PRODUCT CHANGE NOTIFICATION

PCN003/2021 - CHANGED POSITION AND LENGTH OF THE SWITCH CABLE OF TRACK CONTROLLER HARNESS

PRODUCT AFFECTED 03300 – Track Controller Harness

New Track Controller harness

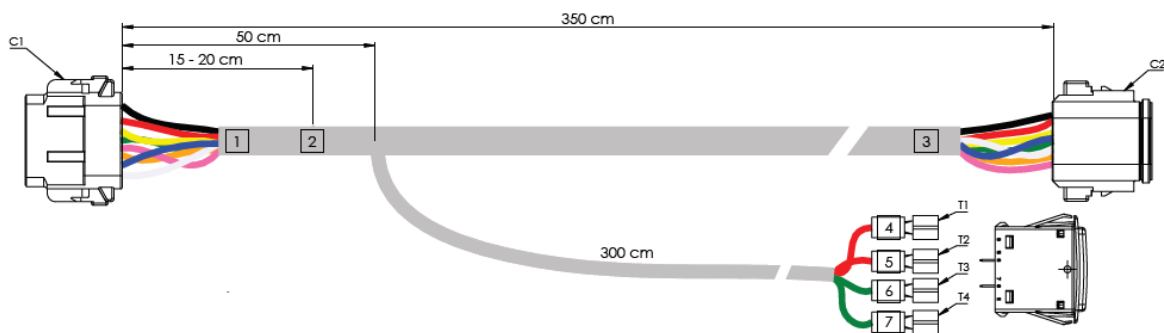
The position and length of the switch cable on the Track Controller harness were changed. The cable will start 50cm from ECU connector and has now 300 cm in length.
